MicroSmart Pentra FC5A BUG REPORT

Type: FC5A-D16RK1/-D16RS1/-D32K3/-D32S3

Firmware Version : 210 (Included in WindLDR version 5.32)

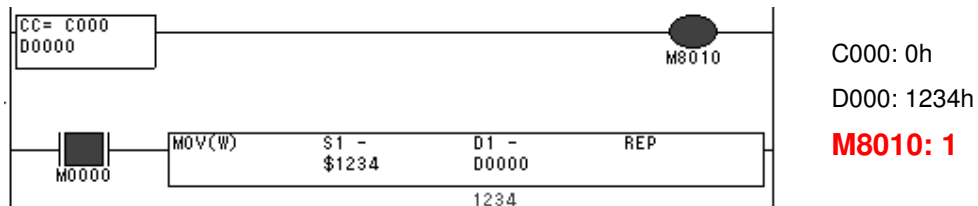
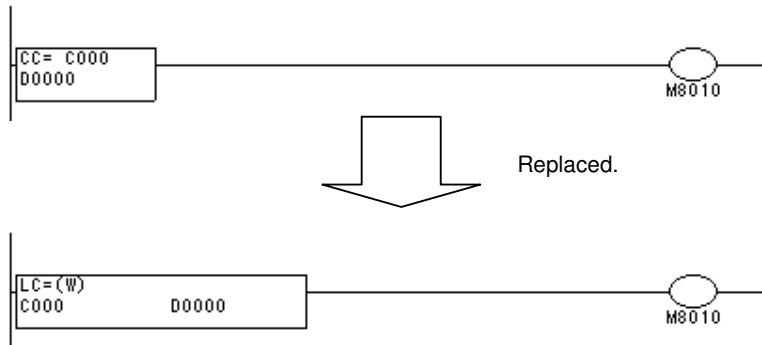
1. Create the following ladder program in WindLDR.

2. Turn on M0000. (1234h is moved to D0000.)

M8010 is turned on even though D0000 and C000 are not equal.

This problem occurs when the preset value of the CC(Counter Comparison) instruction is D0-D1999 or D8000-D8399.

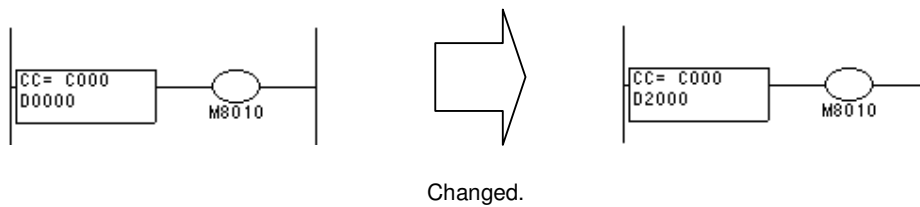
CC (Counter Comparison) instruction in the FC5A firmware version 210 in conjunction with LogicEngine version 110 or 120 does not operate correctly.

1. Replace the CC instruction with the LC (Load Compare) instruction.
